Addendum 02
2022 Bond
Painting Project Districtwide
Package A
Package B

Pasadena ISD
CSP#26P-040LP

22 May 2026

This addendum modifies the original Bid Proposal Documents dated April 29, 2026 and forms a part of the Contract Documents.

SULLIVAN MIDDLE SCHOOL
A1
CONSTRUCTION DOCUMENTS

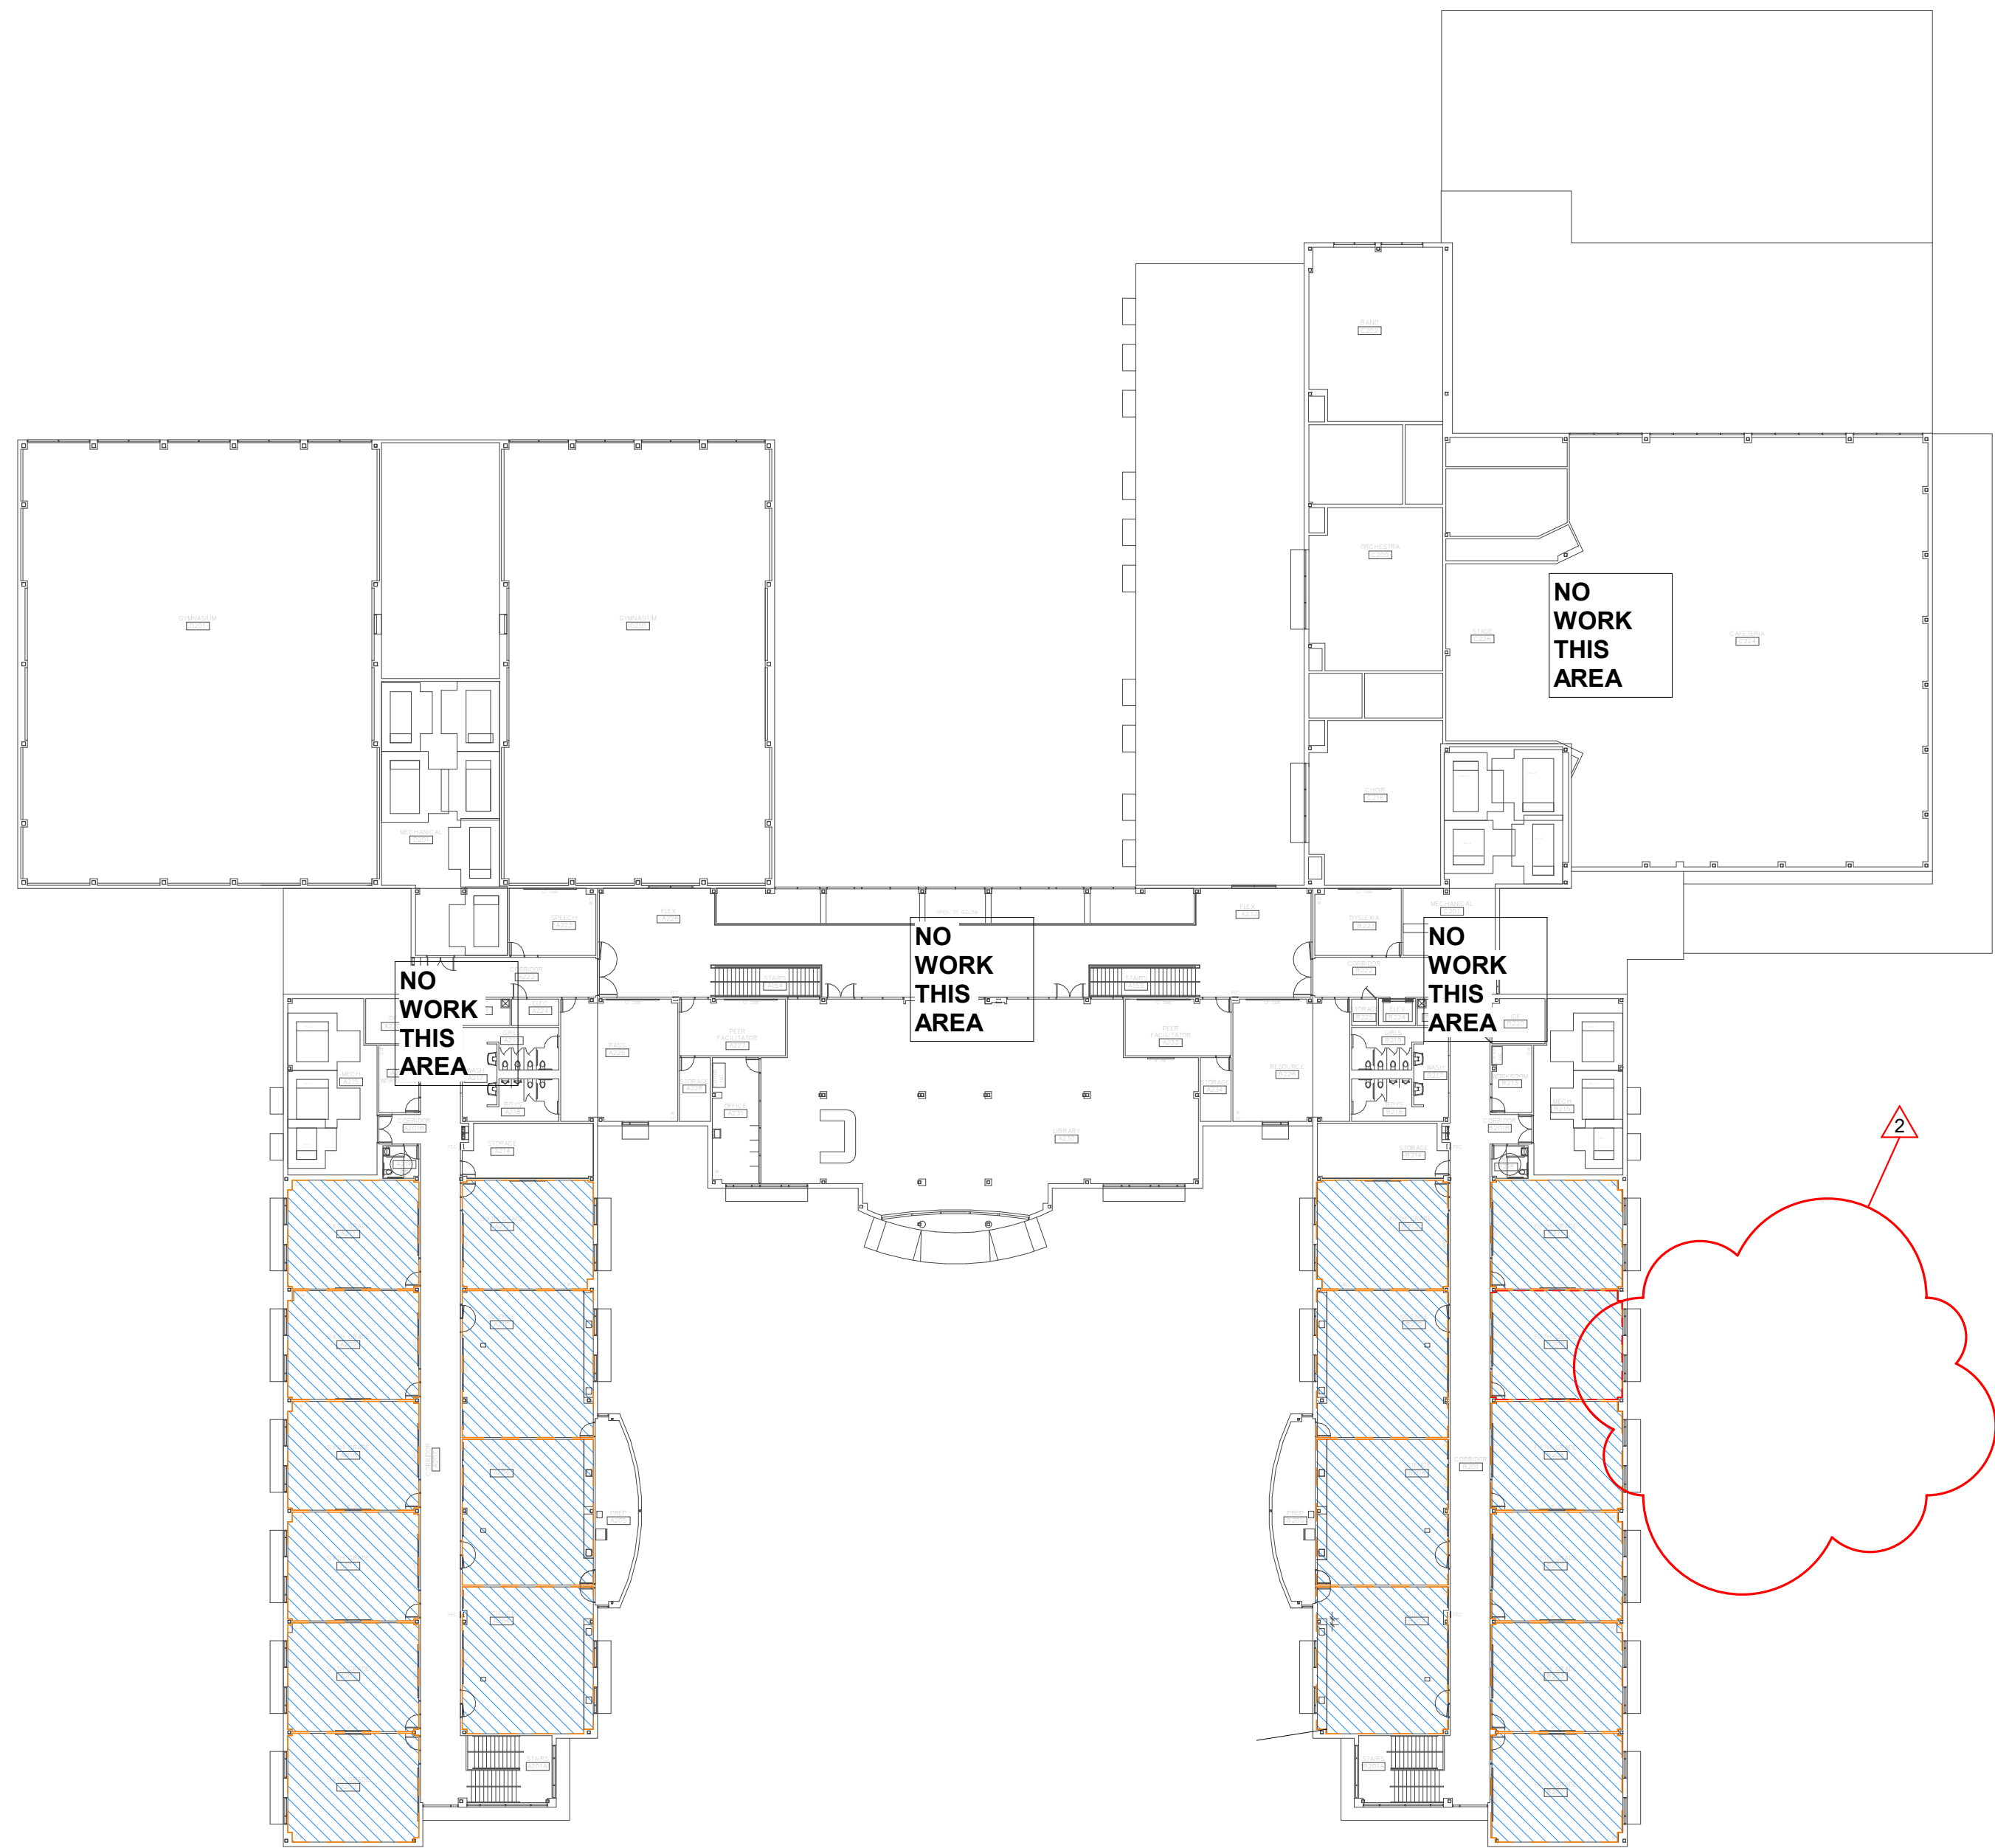
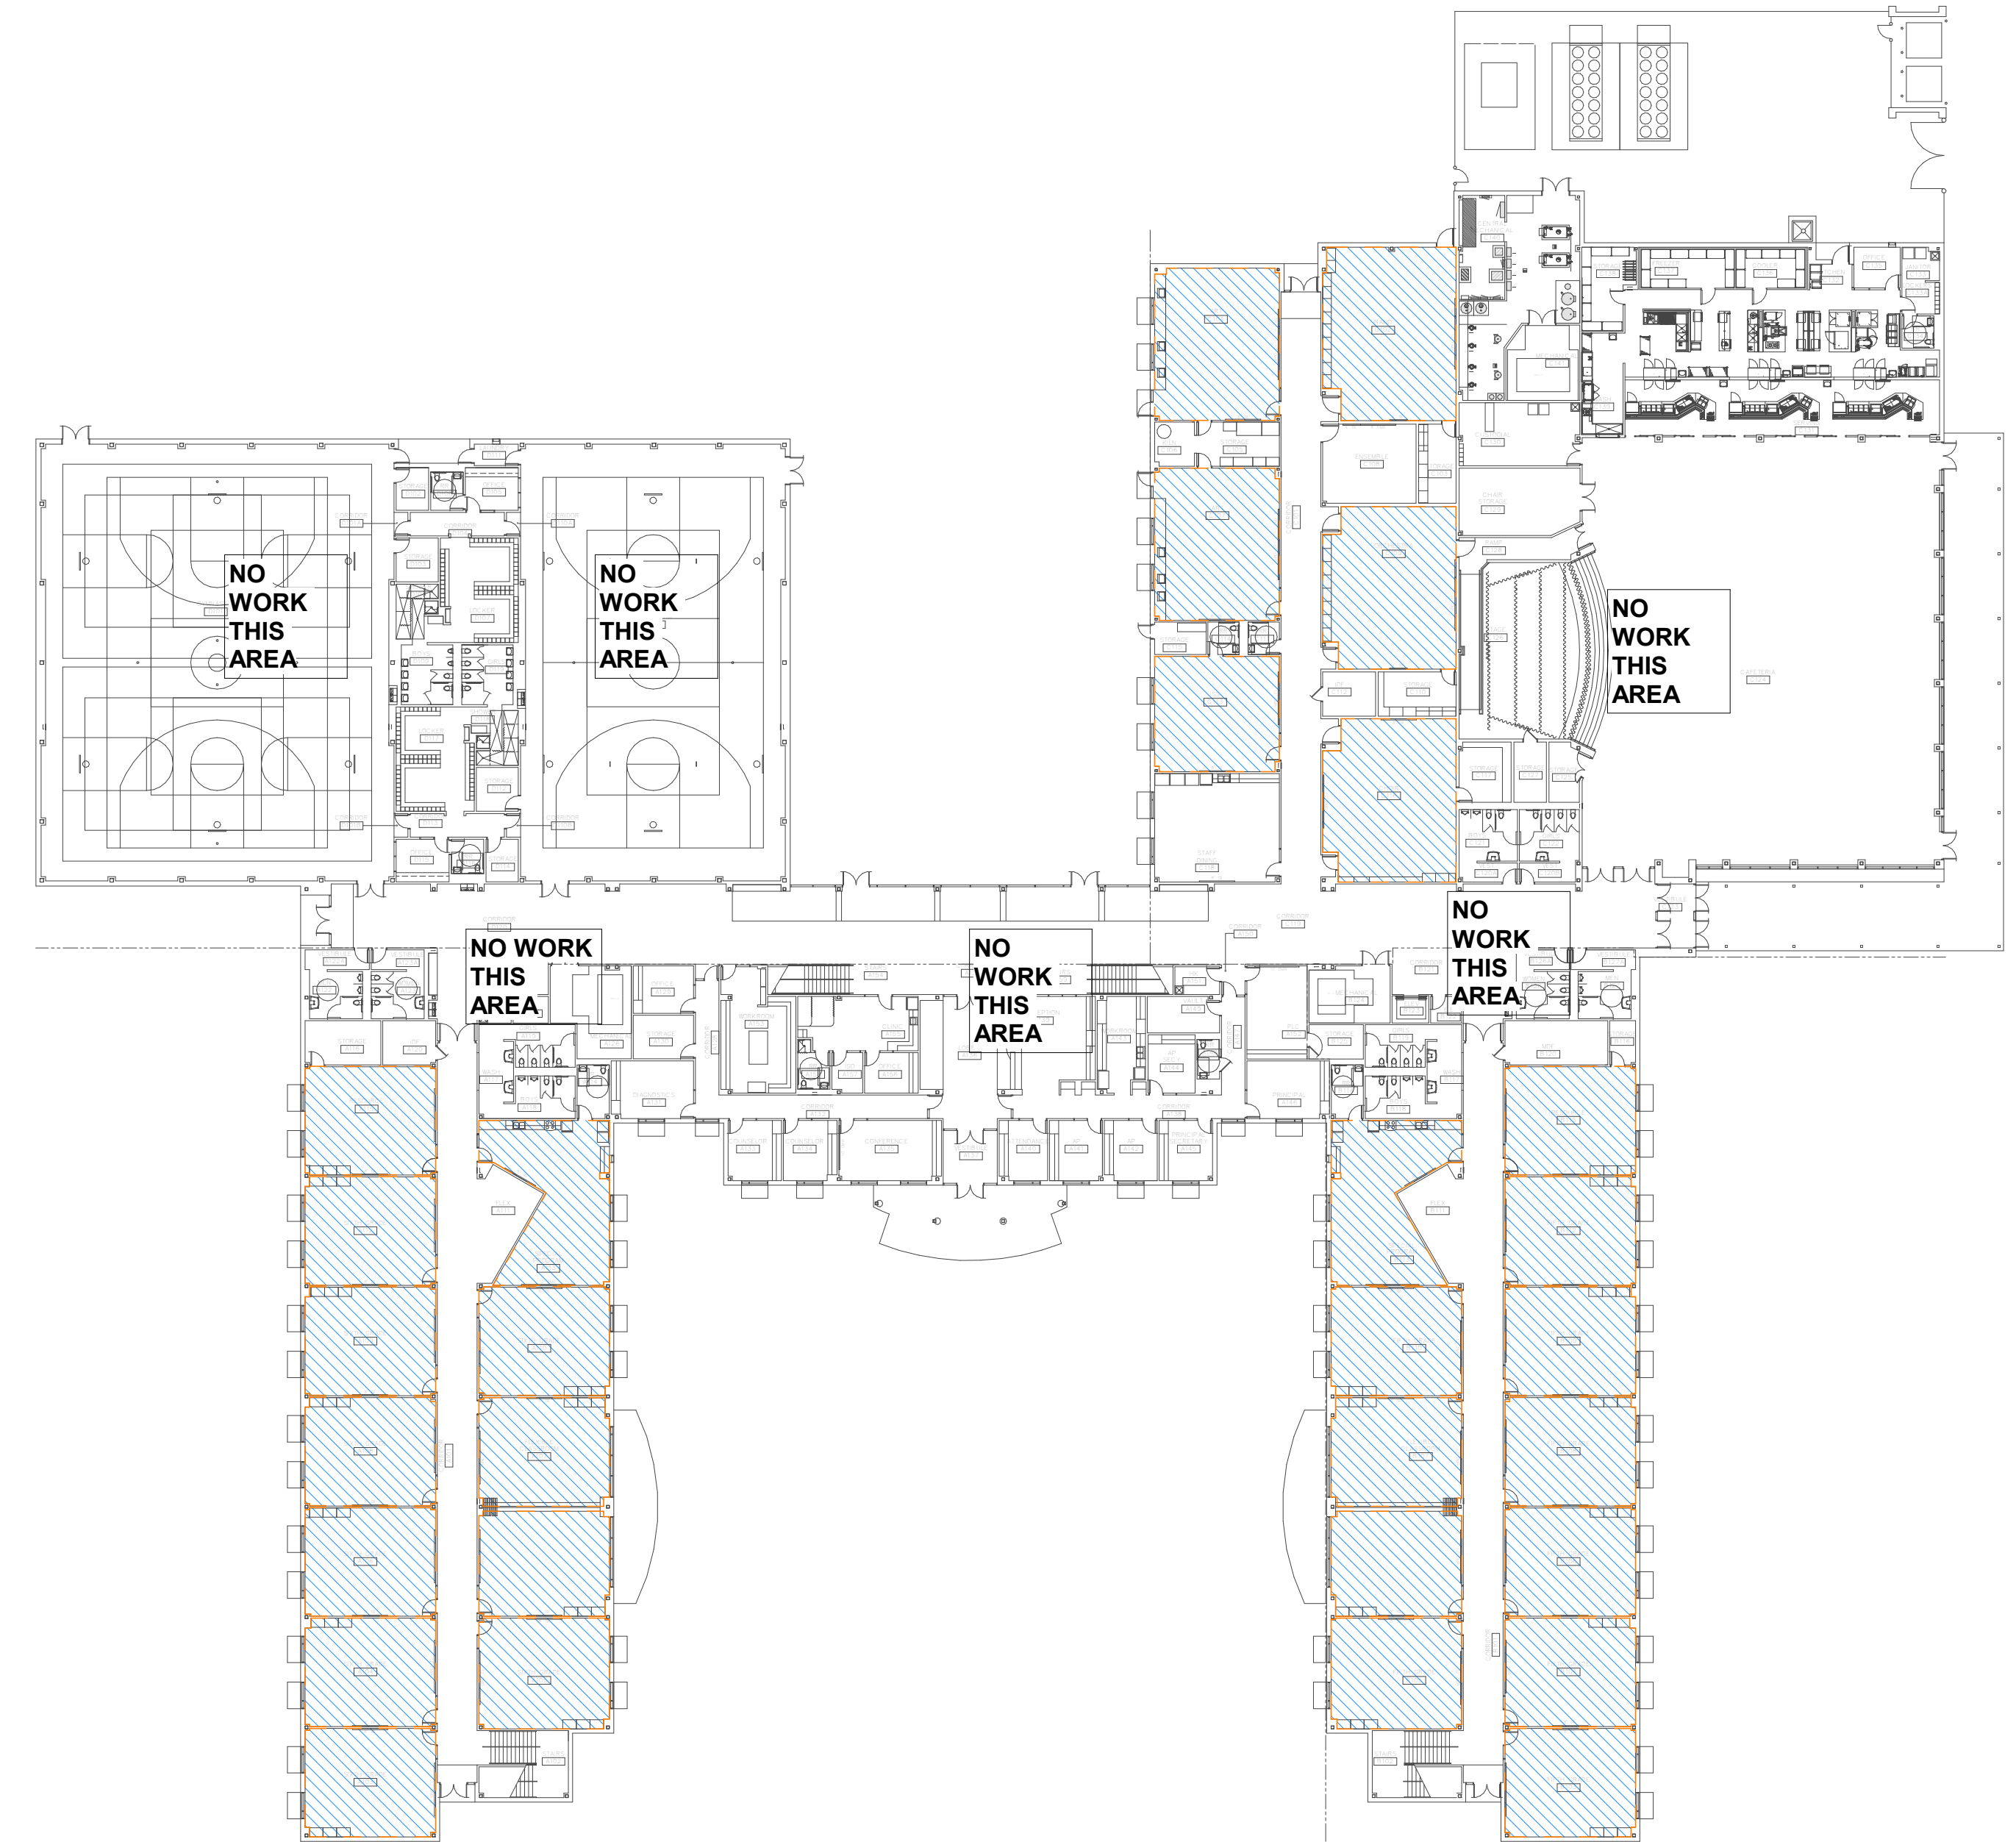
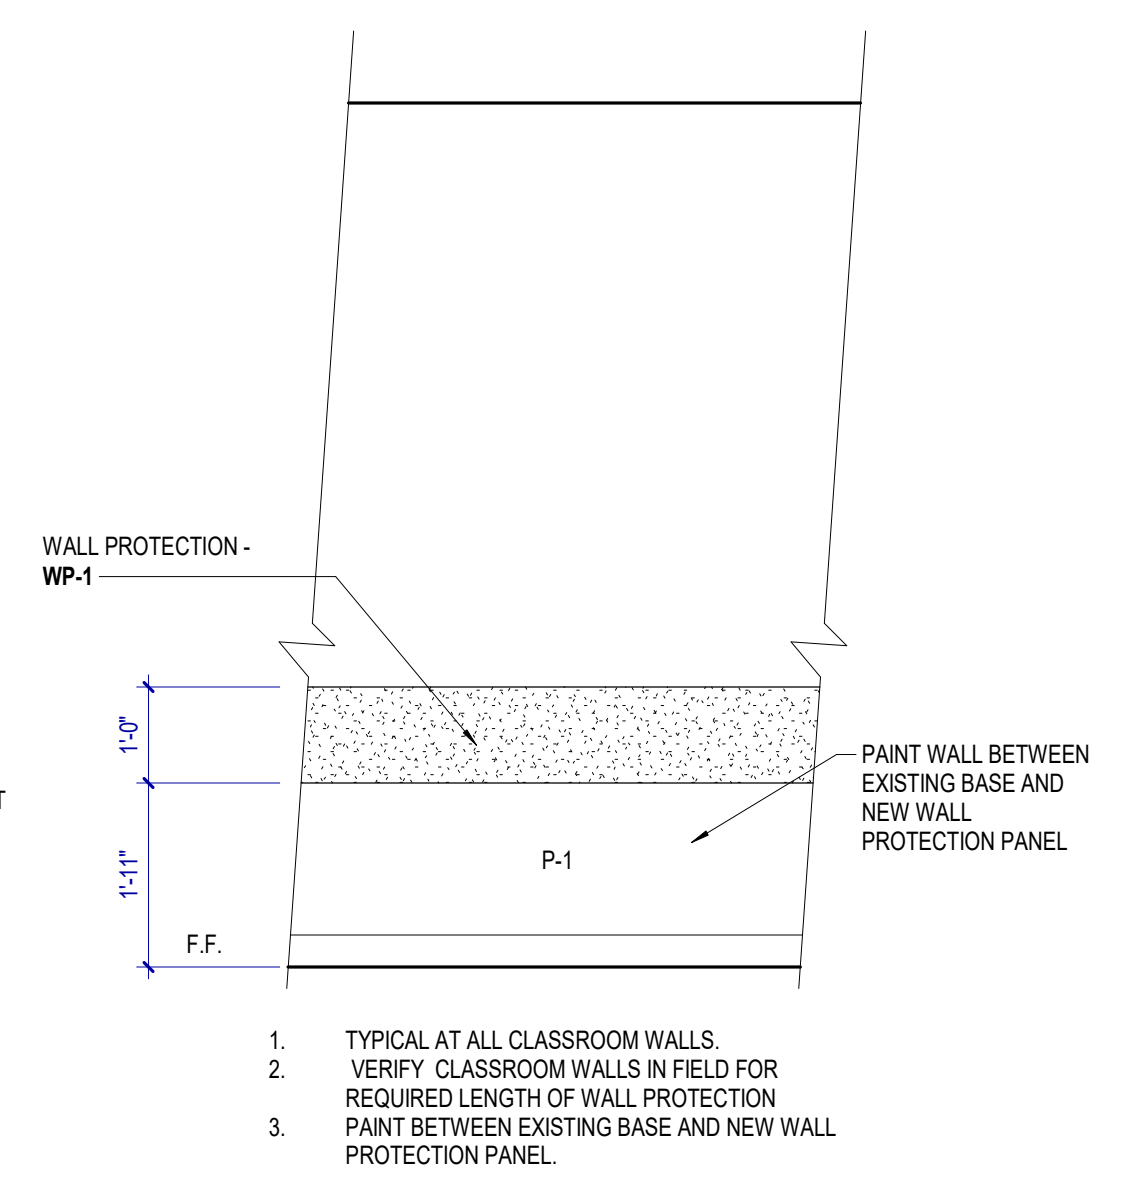
- 01 A1 – Sullivan Middle School: Replace with Revised Sheet A1.
 - a. Paint Classroom Walls, Hollow metal door and window frames in Classrooms
- 02 A2 – The Summit Replace with Revised Sheet A2.
 - a. Remove existing base in Gymnasium and provide new base to match existing.
 - b. Paint Hollow Metal Door and Window frames on both sides, Typical.
- 03 A3 – De Zavala Middle School Replace Revise Sheet A3.
 - a. Remove vinyl wall covering in classrom wall, Paint P-1.
 - b. Paint Gymnaisum walls and steel structure to existing Metal Wall Panel height.
 - c. Paint Dining room cmu walls and steel structure to existing Metal Wall Panel height. Paint background of existing wall graphics. Existing wall graphics to remain.
 - d. Replace Revise sheet A3.
- 04 A4 – Jackson Intermediate School: Replace with Revised Sheet A4

REPAIR WALL AND PROVIDE WALL PROTECTION WP-1 PER DETAIL 3A1 TYPICAL AT ALL CLASSROOM WALLS.

LEGEND
INDICATES AREA OF WORK. PAINT CLASSROOM WALLS. PROVIDE WALL PROTECTION PER DETAIL 3A1 ON ALL EXPOSED CLASSROOM WALLS.
